Jetter

**Technical Information
Version Update**

October 10, 2003

JX6-CON-Move Modifications from Version 3.001 to Version 3.023

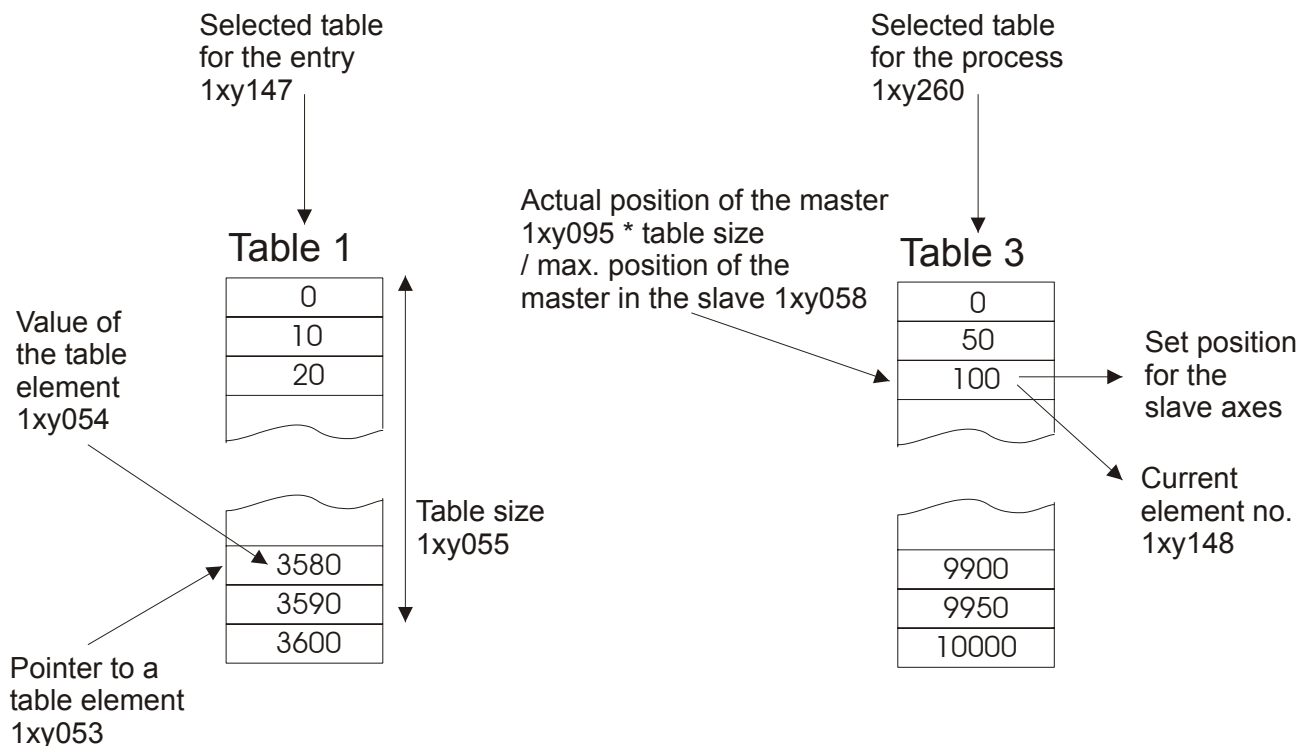
- (3.004) Starting from this version, the tables can be entered and processed separately. This means that it is possible to enter another table while a table is being processed. The new register 1xy260 serves to select the table for the process.

The following diagram illustrates the entry and process of various tables:

As in previous versions, different table sizes are allowed. As long as register 1xy260 is not written, register 1xy147 is used as selected table for the process.

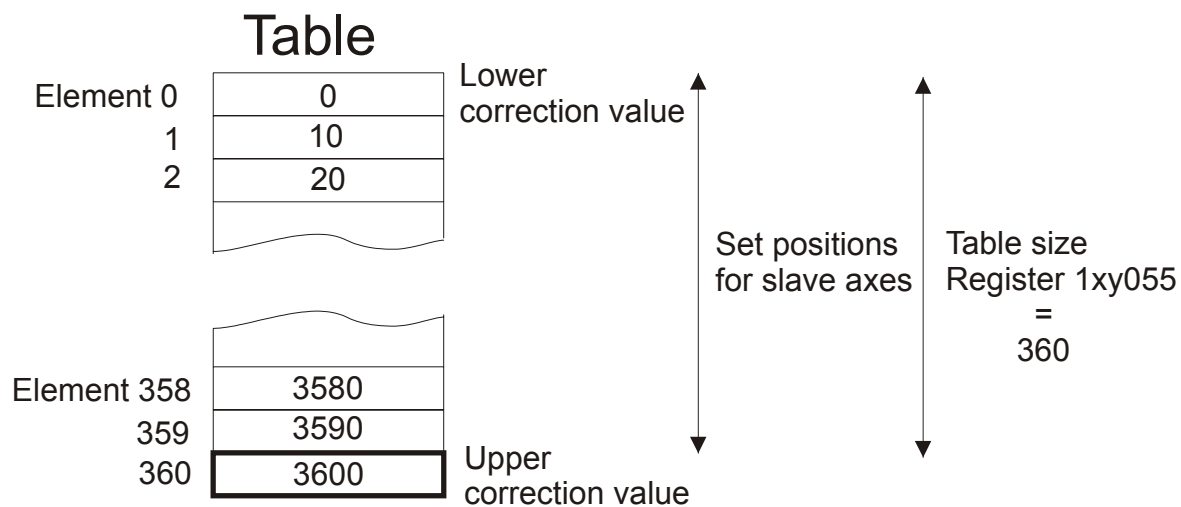
- (3.002) When recording the actual position in JetSym or Sympas oscilloscope mode, the values might have been incorrect.
- (3.003) Starting from version 2.900, an error might occur when creating a table if a table was written before using a too extensive table pointer.
- (3.004) Starting from version 2.900, the correction value during table mode overflow applied to the last table element. Starting from this version, the correction value must be entered again as additional element:

The correction value in case of table overflow is calculated as follows:

Correction value

= Value of the table element (register 1xy055) – value of the table element (0)

= 3600 increments – 0 increments = 3600 increments
